**Design Review Board Case #2018-0001**  
**Carlyle Plaza Two – South Residential Building**

The applicant, Alder Branch Realty Limited Partnership, LLLP; represented by JM Zell Partners, is requesting the Design Review Board's (DRB) review and commentary on the revised design of the low-rise liner units proposed with the first phase of the Carlyle Plaza Two development.

Figure 1-Low Rise Duplex Entry

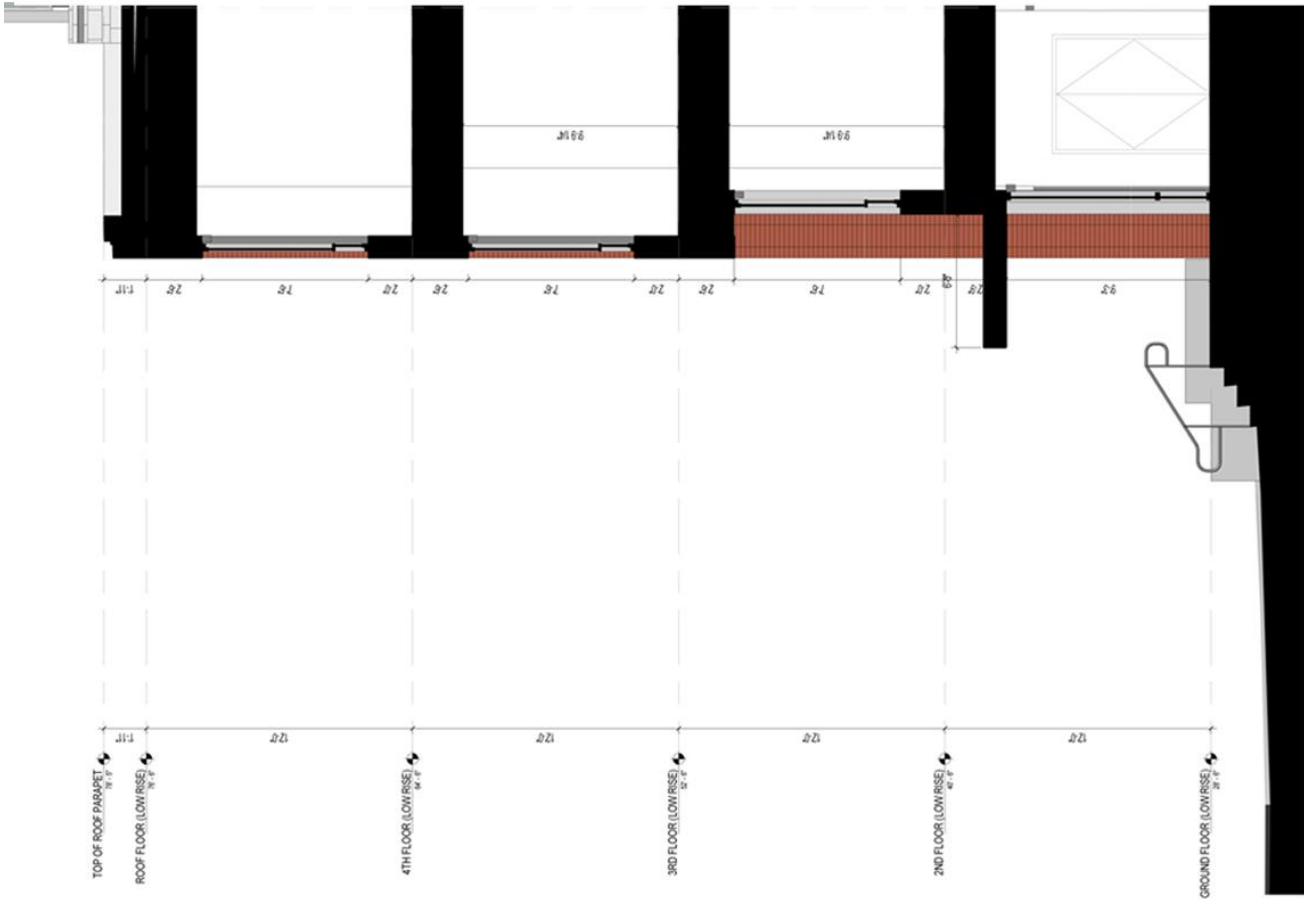
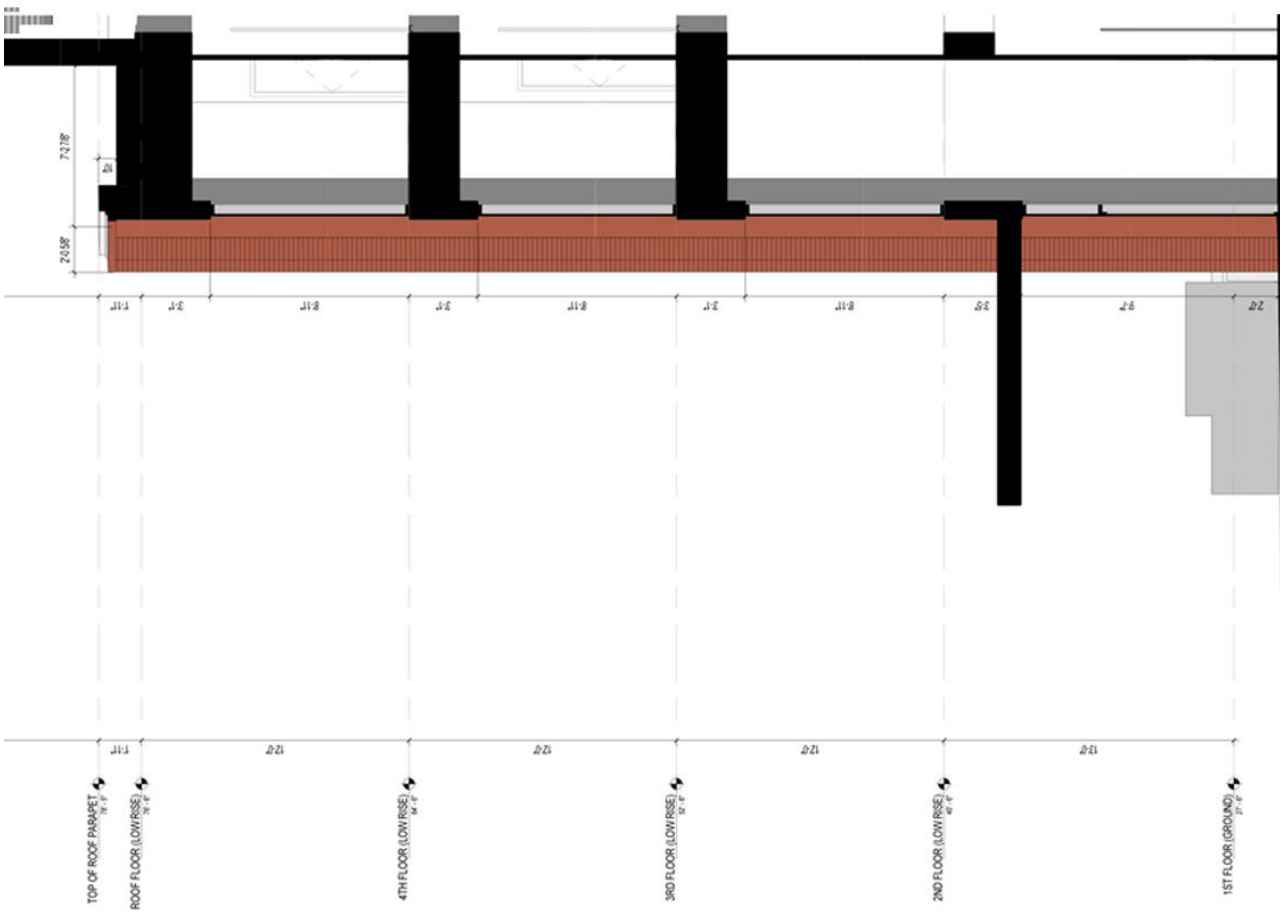
As represented in Figure 1, a 6-inch depth between the front and back planes was proposed in the concept presented to the DRB in July 2016. At that time, the Board approved of the design with the condition that this depth be increased to 12 to 16 inches between the front and back planes. The currently proposed design appears to measure to a depth of approximately 2-inches, which is significantly less than the depth stipulated in the DRB's approval.

1. Maximize the depth between the front and back planes of the west façade to comply with the DRB's condition of approval for a 12- to 16-inch depth between planes.

Figure 2-Low Rise Lobby

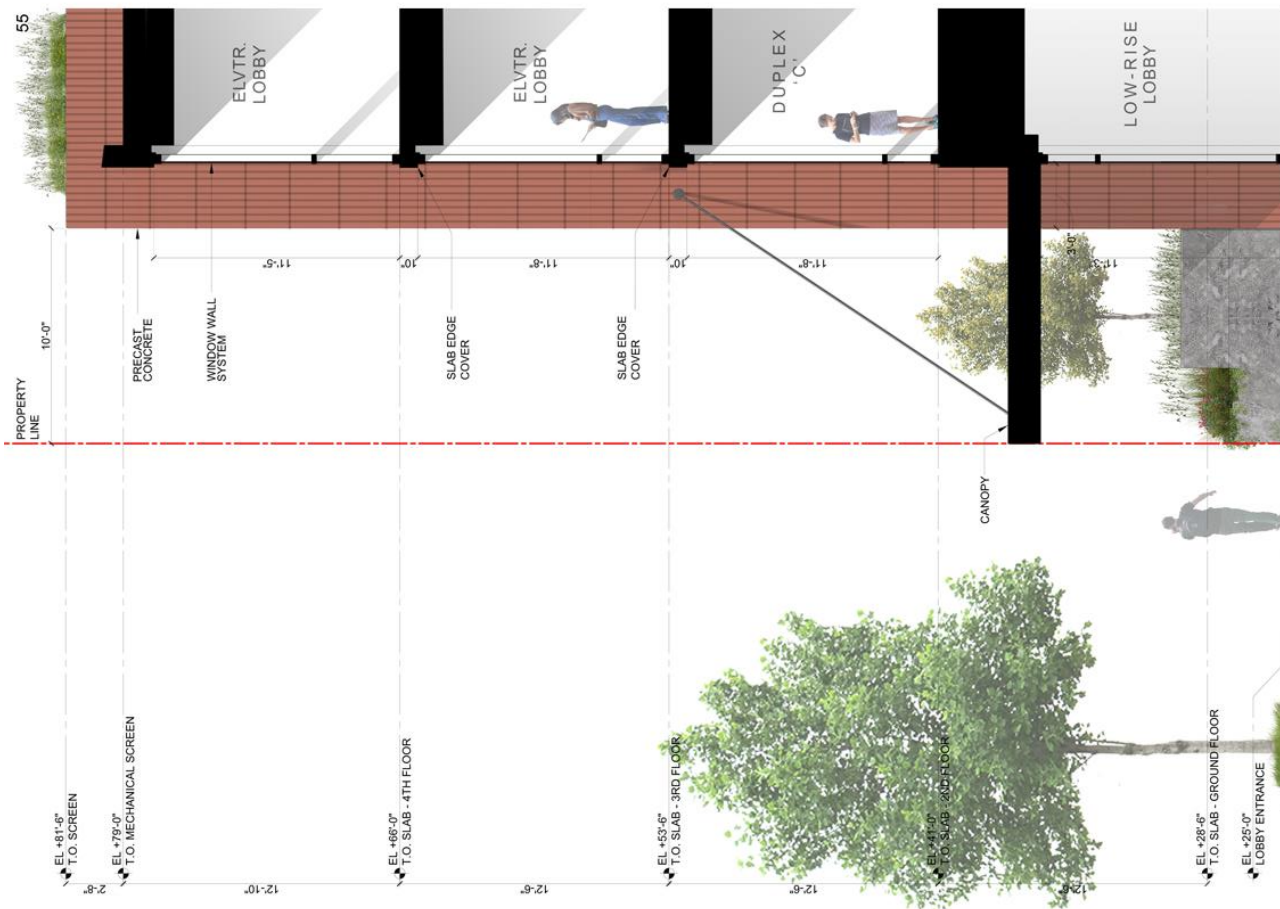
Another significant contributor to a sense of depth on the west building façade is the distance between the face of the window wall system and the face of the masonry. The originally approved design, as represented in Figure 2, illustrates a dimension of 3 feet between the face of the masonry and the window wall at the lobby entrance. Additionally, Figures 3 and 4 illustrate a distance of 1 foot between the façade masonry and the typical window wall at the duplex and loft units in the approved design.

The current design proposes approximately 2 feet between the face of the window wall of the lobby and the face of the masonry. Additionally, the distance between the face of the masonry and the window wall at the duplex and loft units is minimal, appearing to measure between 2 and 3 inches.

3. Increase the depth between the face of the window wall system and the face of the façade masonry to conform with the approved design.
4. Increase the depth between the edge of the balconies and the face of the façade masonry.

Figure 3 – Duplex Balcony 1

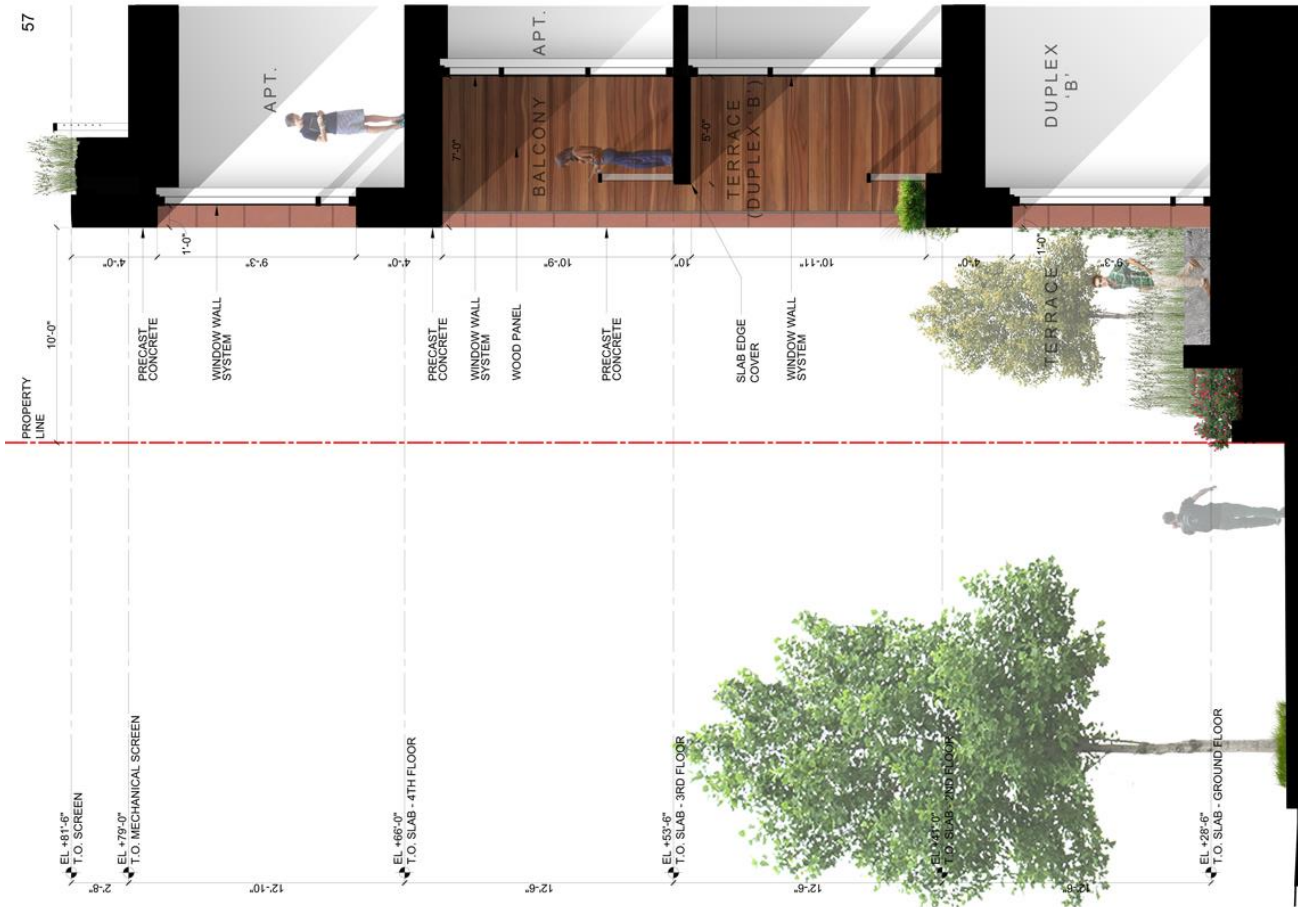
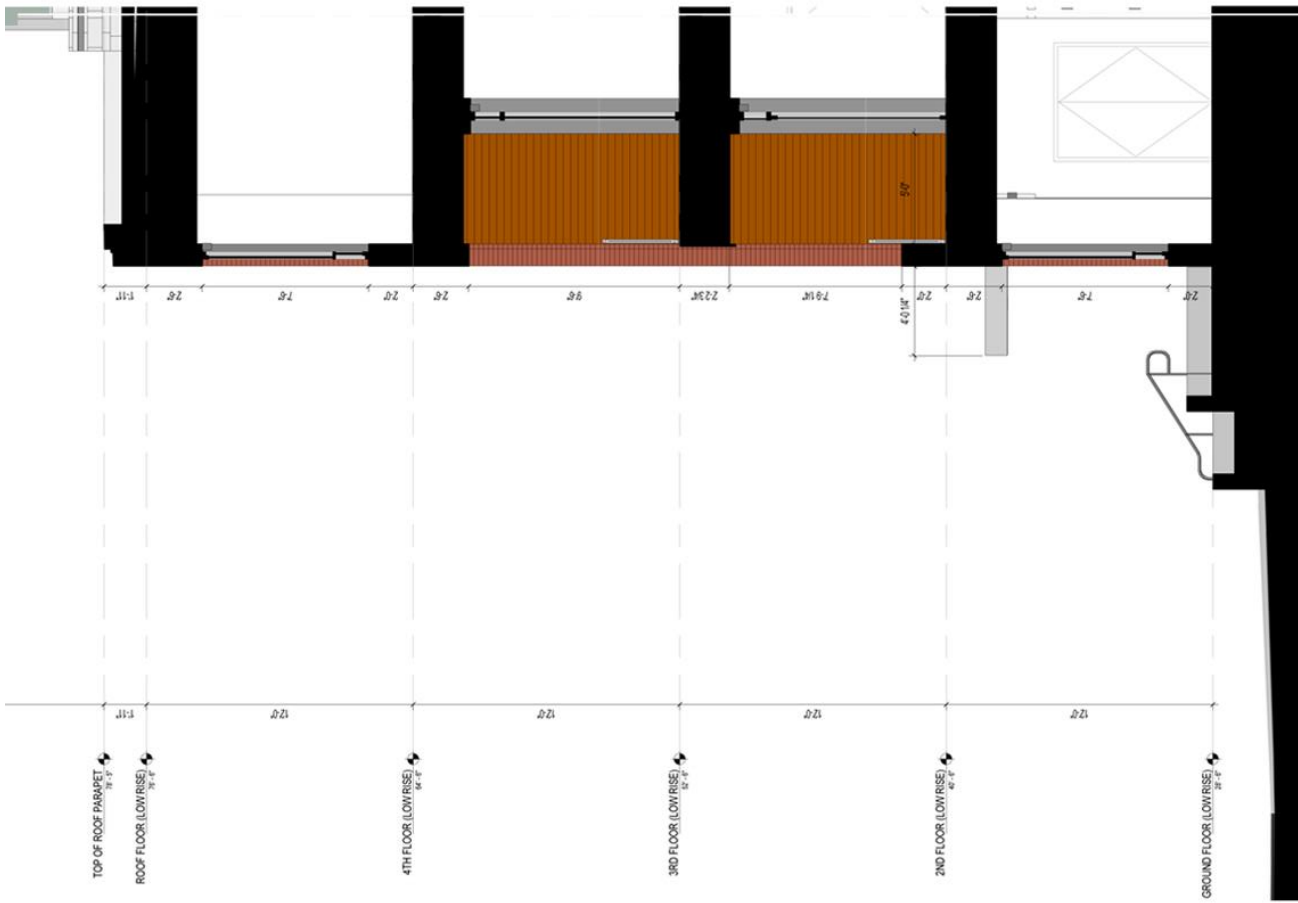
The third significant change to the depth of the west building façade is the reduced distance between the edge of the balconies and the face of the masonry. The approved design, as shown in Figures 3 and 4, proposed 2 feet of depth between these building elements. Planters were proposed within this setback at some of the residential units which further enhanced the complexity and texture of the façade, and helped to tie the low-rise façade visually to the terraced private yards below.

The current design provides approximately 6- to 8-inches between the edge of the balconies and the face of the masonry. Additionally, the approved planters had provided both relief and interest to the façade, but have been removed from the current proposal, resulting in a very different feel to the quality of the architecture. The overall result is a flattened façade appearance with little or no variation in depth between building elements.

Figure 4 – Duplex Balcony 2

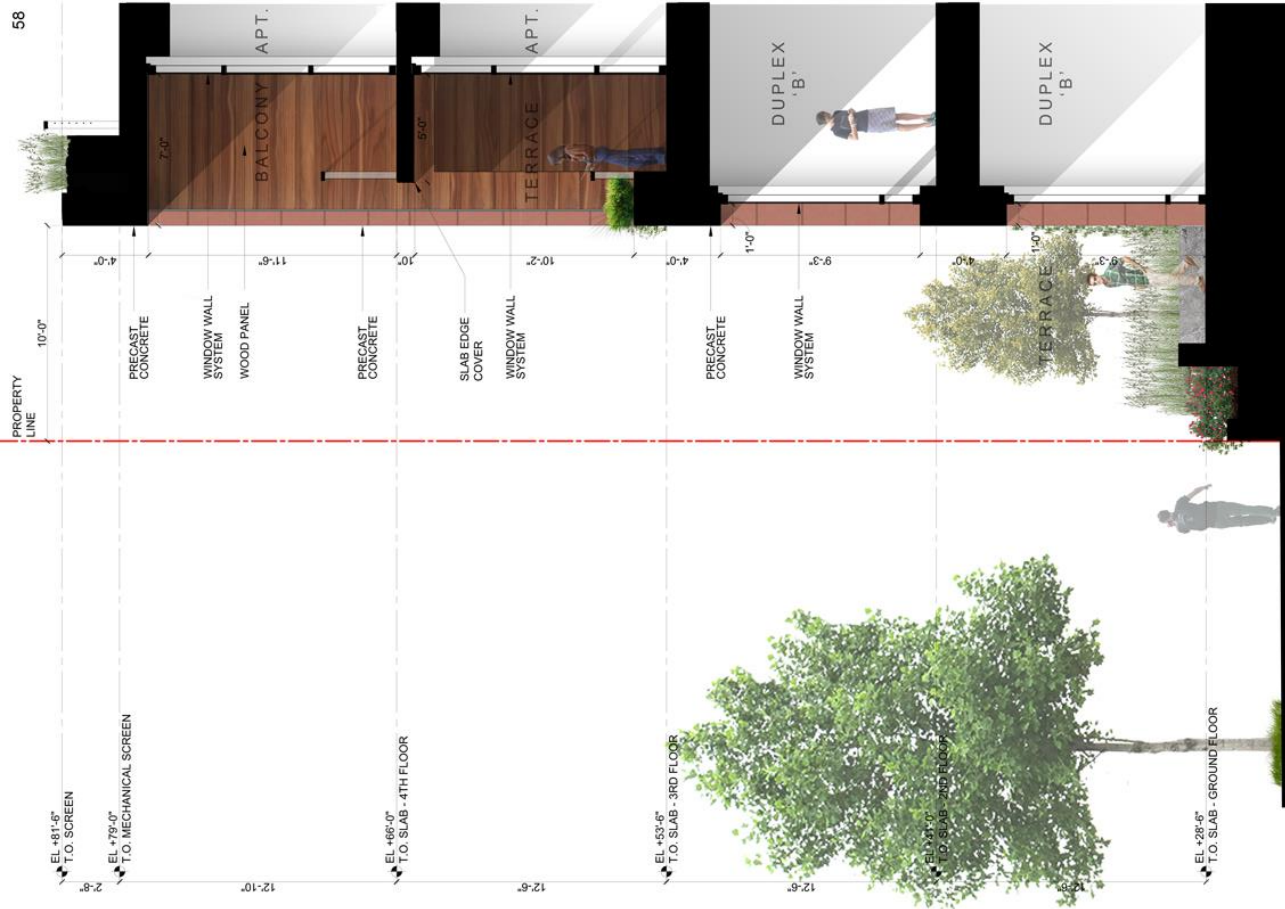
As mentioned above, the approved design incorporated planters into the 2-foot setback between the balconies and the façade masonry, as well as at the top of the building. These planters provided texture, depth, and enhanced interest to the façade in addition to screening at the roof level. Elimination of this feature also diminishes the original intent of the liner units as a garden-like residence.

**Figure 5 – Low Rise Building Elevations**

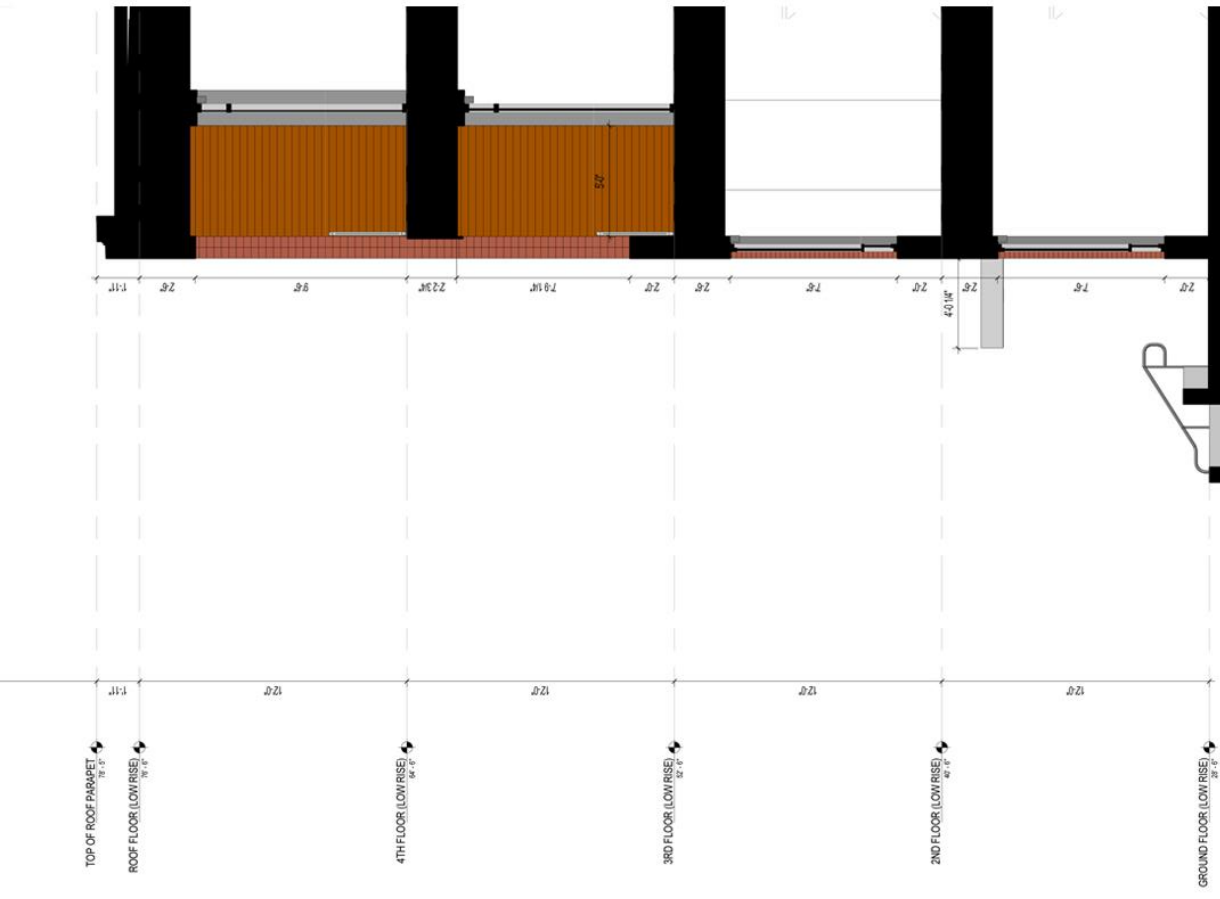
The total building height measured from the finished floor of the duplex units to the main roof was 50’-6” at the time of the DRB’s approval in July 2016. Now, the proposed building height is 48 feet when measured from the same points. Although a 2 and one-half foot difference in height may seem insignificant, it is apparent that this reduced height has negative effects on the proportions of the west building façade and the overall relationship of the low-rise building to the South Residential Tower (see Figure 5).

Firstly, one consequence of reducing the building height is the effect on the double and single height windows which face Bartholomew Street and Limerick Street. The shape of the glazing appears nearly square in the revised design, rather than rectangular as originally approved. The rectangular proportion of the approved glazing is a more elegant proposal which contributes to the overall success of the façade’s design.

Further, the top of the low-rise liner building aligned with the top of the 5<sup>th</sup> floor glazing on the South Residential Tower in the approved design. This was a successful relationship that reinforced the clean lines and geometry of the overall project and created

a smooth transition of the South Tower to the ground. Now, the top of the low-rise liner building is noticeably/substantially below the top of the South Tower's 5<sup>th</sup> floor glazing, creating a somewhat broken transition between the two buildings. Although a 2-foot increase to the height of the 5<sup>th</sup> floor was approved by the Board in March 2017, the applicant did not communicate a revision to its relationship with the low-rise liner building, which is under no height restriction.

While the proposed method of screening the bulkhead is not shown in this submission, it is evident (see Figure 5) that the bulkhead as shown is not integrated into the overall architectural expression and materials palette of the building which is a requirement of the Eisenhower East and Carlyle Plaza Two Design Guidelines.

5. Provide a solution that aligns the top elevation of the low-rise liner building with the top of the South Residential Tower's 5<sup>th</sup> floor glazing. Subsequently, revise the shape of the single and double height glazing on the liner units to be in better proportion within the overall façade. These goals could be achieved by adding incrementally to the floor-to-floor heights in the building.

6. Per the Eisenhower East and Carlyle Plaza Two Design Guidelines, provide a solution that screens the elevator bulkhead in a way that is integrated into the overall architectural expression and materials palette of the building.

**Figure 6 – Low Rise Building Elevation**

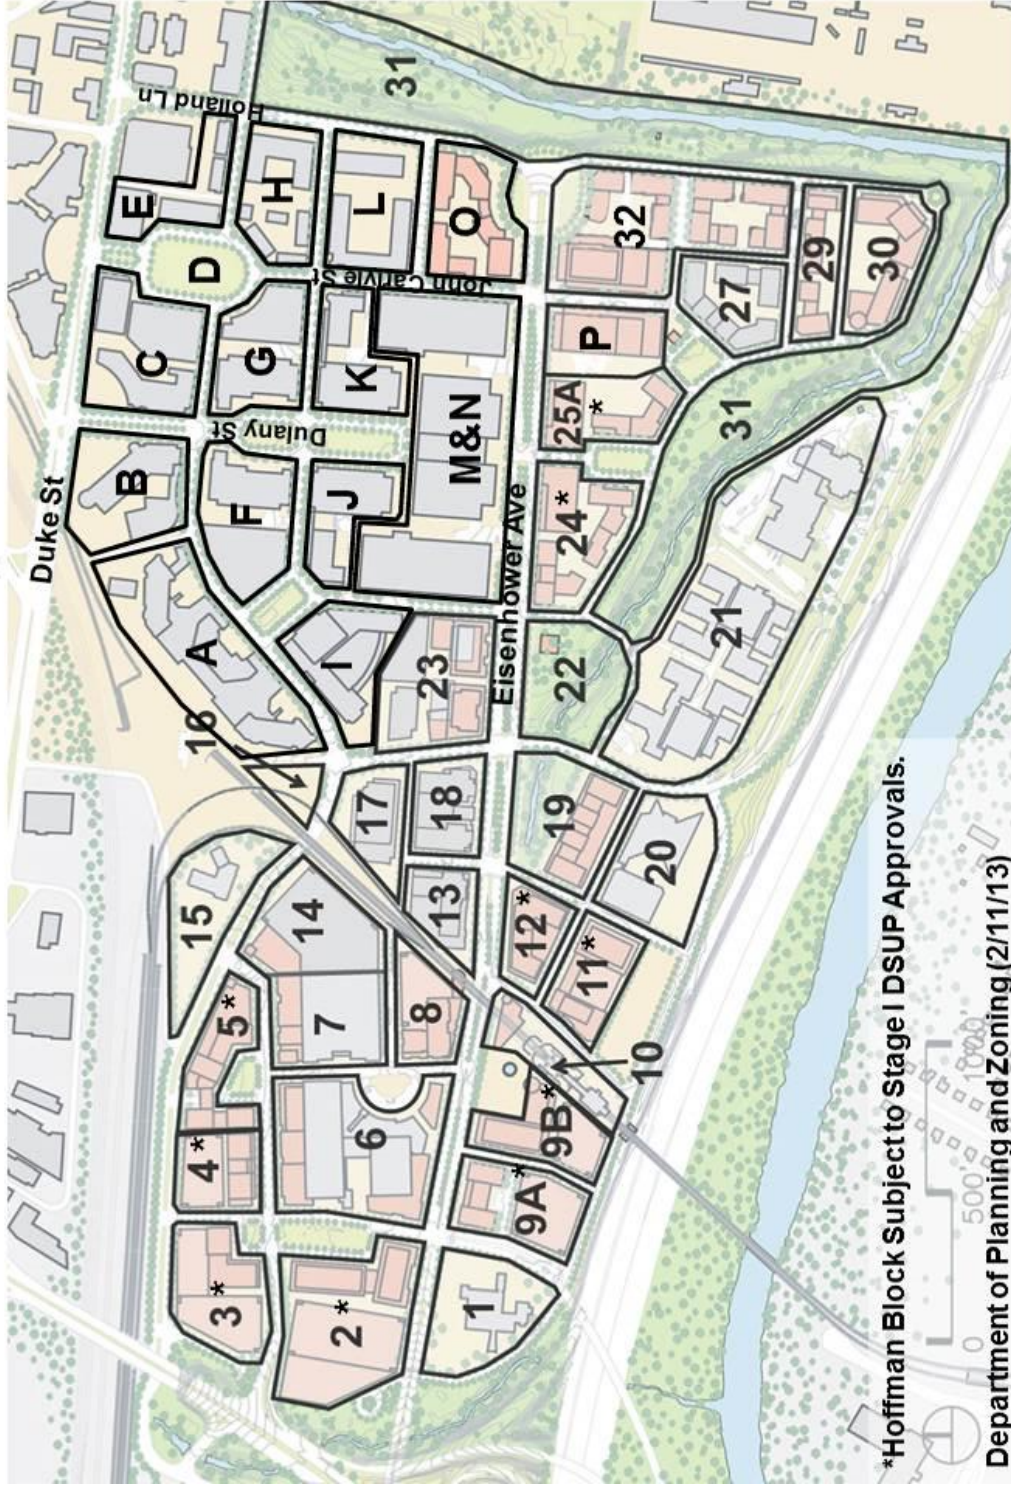
The primary, west-facing, façade of the low-rise liner units is comprised of two planes defined by an offset between the face of the building materials. The front plane forms a series of steps that cascade across this façade providing both horizontal and vertical movement that relates to the cascading effect of the glazing pattern proposed on the South Residential Tower (see Figure 6).
